**TRANSPORTATION BOARD MEETING**  
**Monday, January 13, 2020 @ 7:00 PM**  
**Select Board Hearing Room, 6<sup>th</sup> Floor, Brookline Town Hall**  
**333 Washington Street**

**DISCUSSION AND ACTION ON PROPOSAL TO DISCONTINUE THE SIDEWALK ON THE NORTHERN CURB OF TAPPAN STREET TO CREATE AN ADA ACCESSIBLE PEDESTRIAN PATH WITHIN CYPRESS PLAYGROUND:**

### **DISCUSSION AND ACTION ON PROPOSED BICYCLE IMPROVEMENTS SURROUNDING THE BROOKLINE HIGH SCHOOL CAMPUS**

# 2. GREENOUGH STREET CONTRA-FLOW LANE

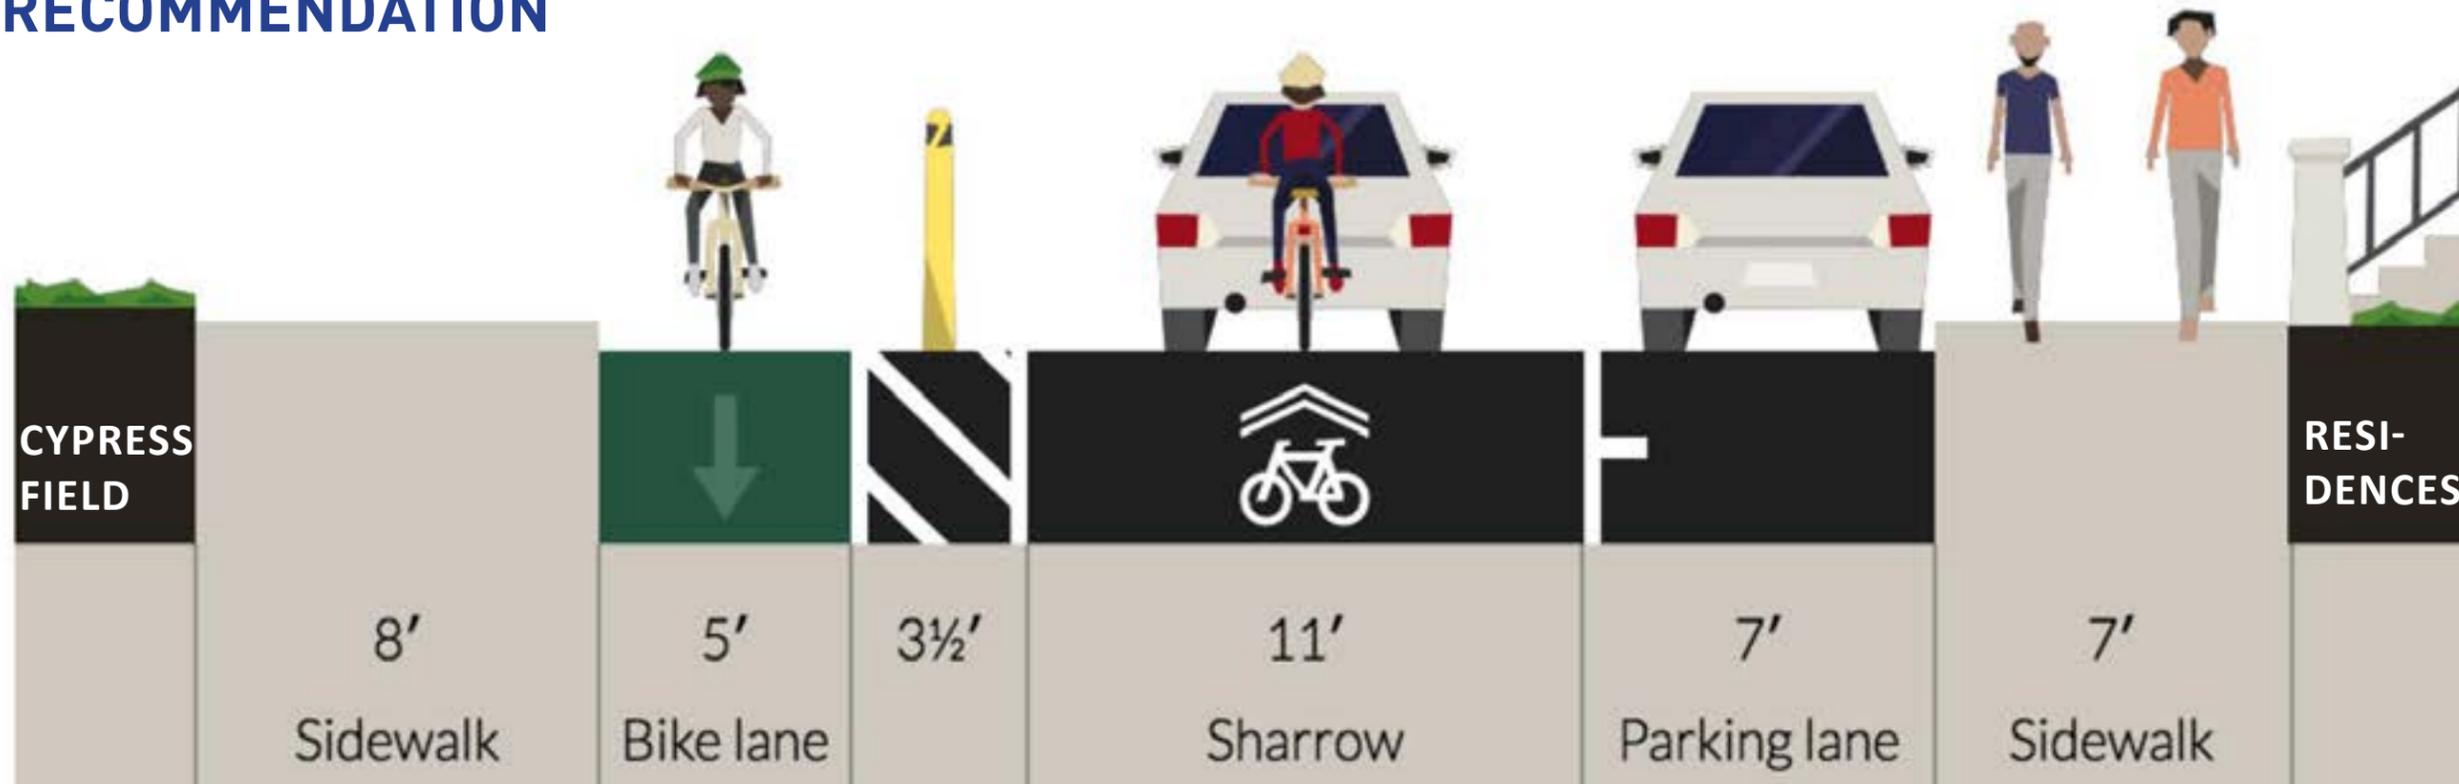
- 8' minimum is required for dropoff. Consider reducing the buffer to 3'.
- The Brookline Fire Department to comment on the drive lane width.

# 4. TAPPAN STREET CONTRA-FLOW LANE AT CYPRESS FIELD (SOUTH)

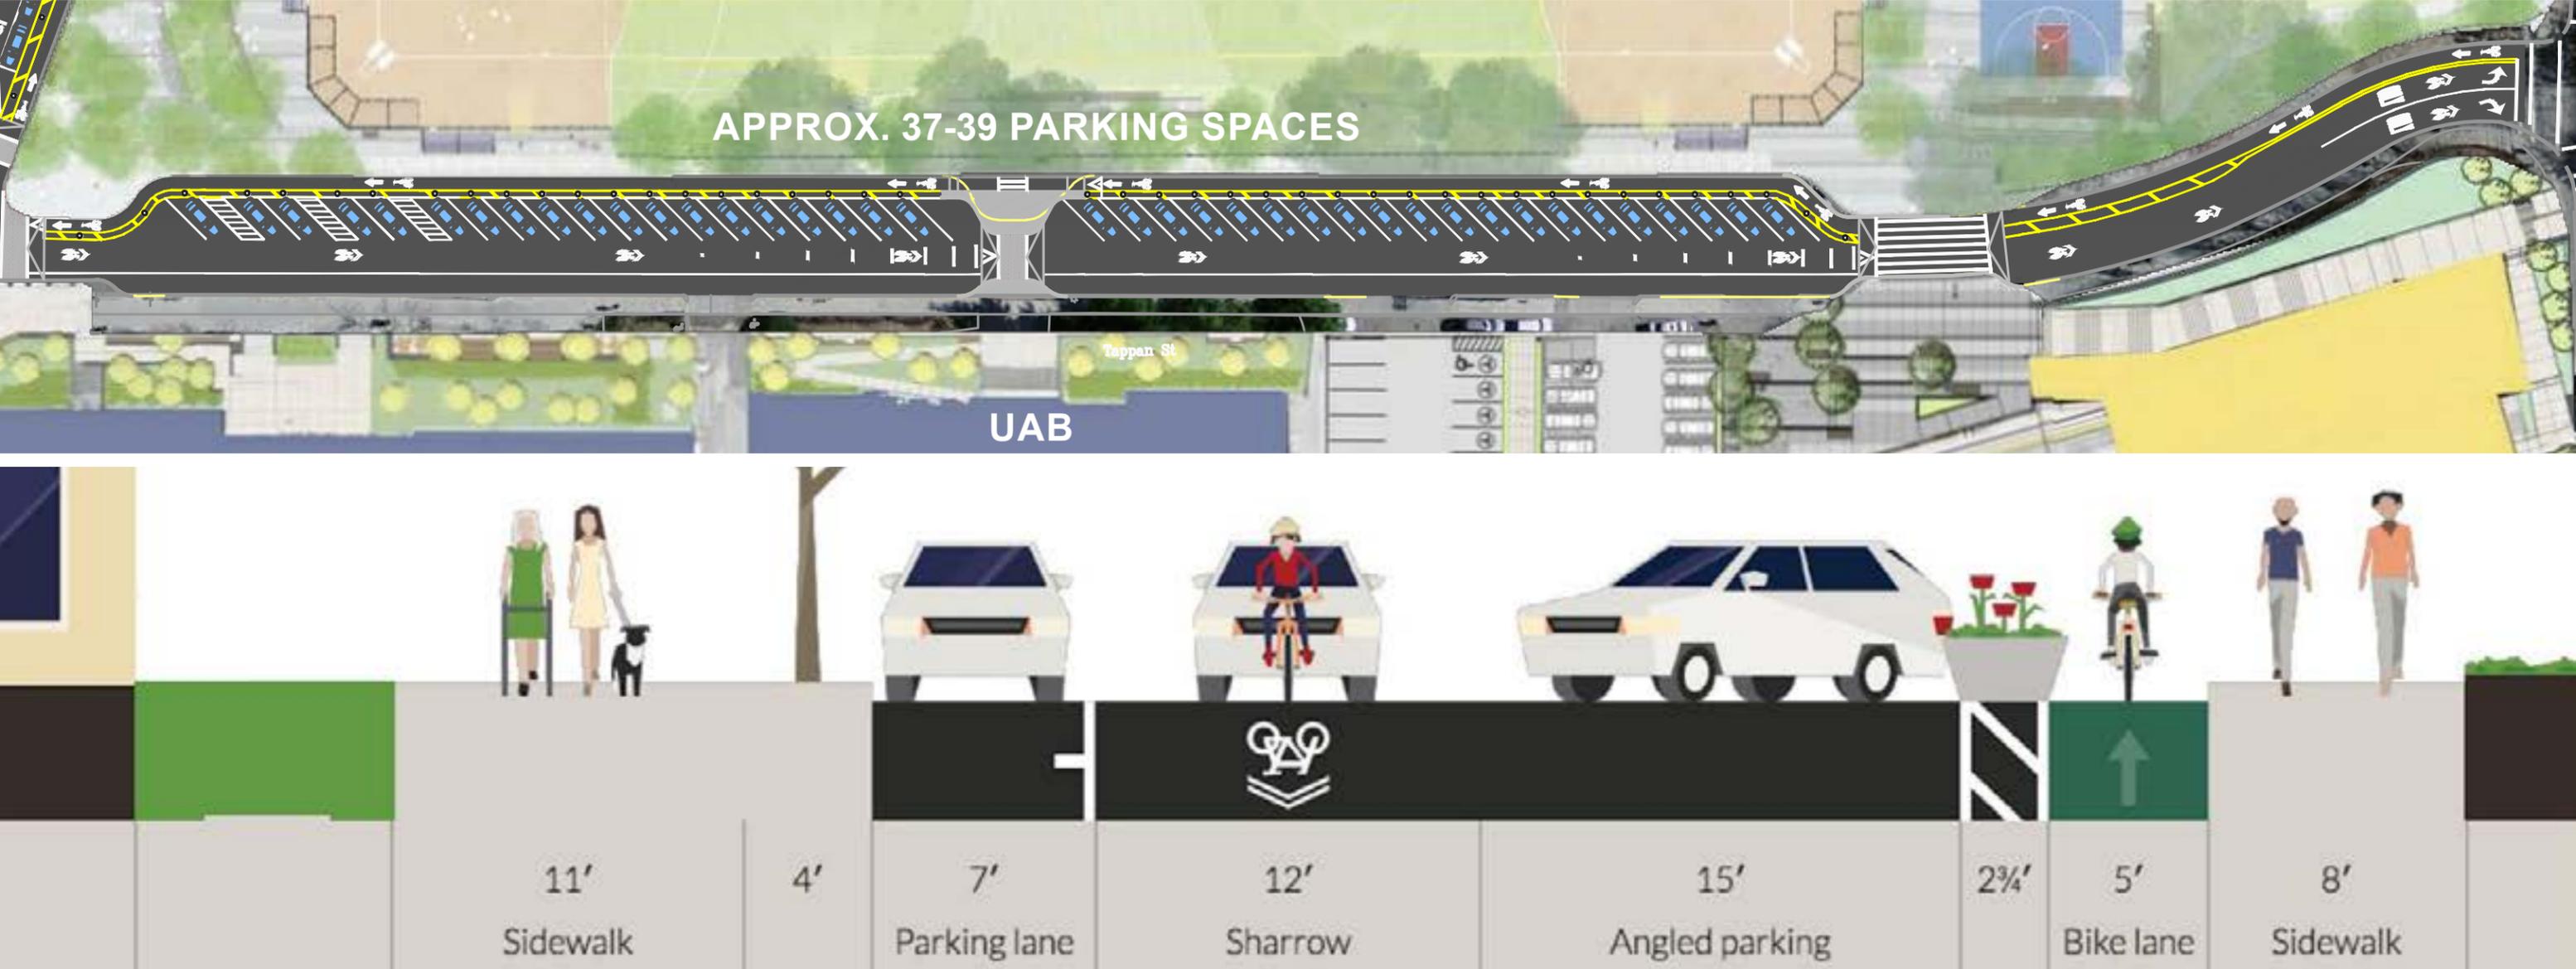
- Parking angle appears to have changed to achieve 15' angled parking.
- The number of parking spaces have been reduced
- The Brookline Fire Department to comment on the 12' drive lane width.
- Consider reverse angle parking and pedestrian safety.

# 5. TAPPAN STREET CONTRA-FLOW LANE AT THE STEM WING

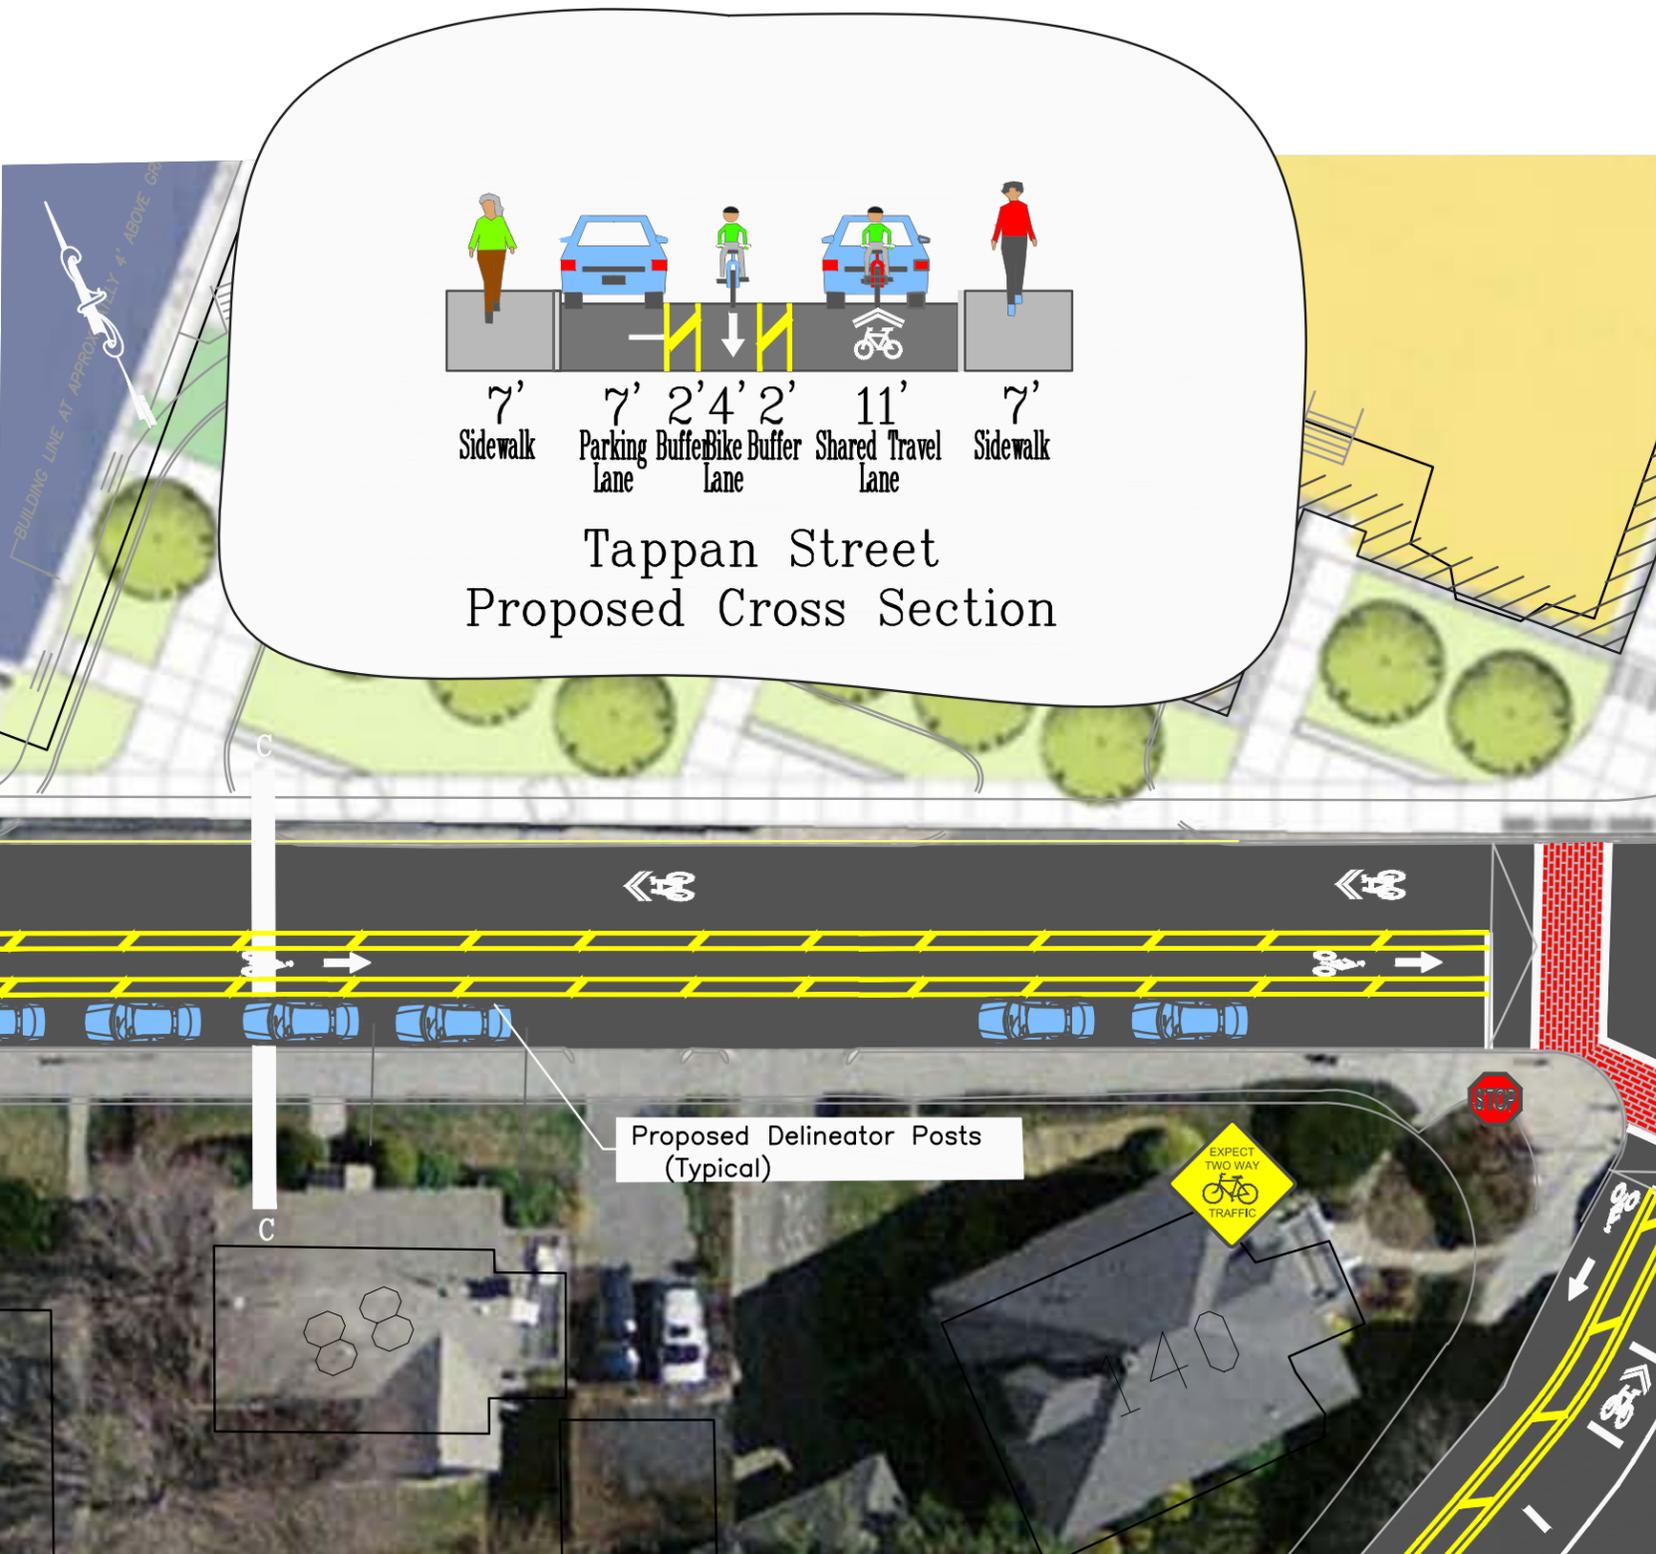
- Dropoff / parking lane is preferred along the north curb
- 8' parking lane required for drop off
- The Brookline Fire Department to comment on the 11' drive lane width.
